GFA AIRWORTHINESS DIRECTIVE

- TYPE AFFECTED:** ASH 26 E. All serial numbers.
- SUBJECT:** Inspection and exchange of the muffler.
- BACKGROUND:** The high grade steel plate of the earlier mufflers turned out to be insufficiently resistant for the inner areas. One muffler showed cracks in the inner area after about 45 hours of operation. A superior material has been used since 1996 and the stronger mufflers are marked with an X at the front plate.

Subject: Inspection and exchange of the exhaust damper of the power-plant. Amendment and corrections to the manuals.

Affected: ASH 26 E, Data Sheet No. 04.883, all serial numbers.

Fig. 1:

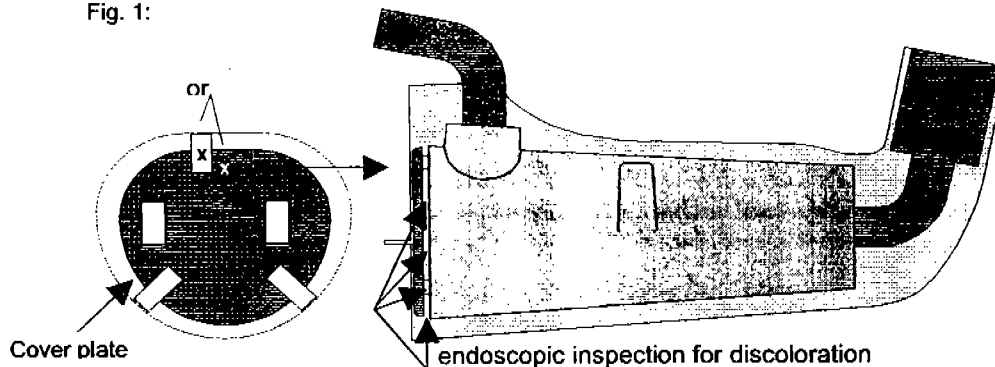
Compliance: Prior to the next engine flight all powered sailplanes must be inspected to make which version of the exhaust damper has been installed. The upgraded exhaust dampers were marked with the letter 'X'. This marking is located on the front side as shown in Fig. 1:

Where the operating time of the exhaust damper is above 40 hours, the front side of the exhaust damper behind the cover plate (see Fig.1) must be additionally inspected for tempering coloration using an endoscope. If this inspection does not reveal any discoloration from the golden-yellow basic coloring changed to a gray or bluish coloration so, a further engine operation in another two hours intervals is allowed. This inspection must be repeated in 2 hours intervals up to a maximum operating time of the exhaust damper of 60 hours.

If damages or discoloration are found during any of the above inspections, the exhaust damper must be exchanged prior to the next engine flight.
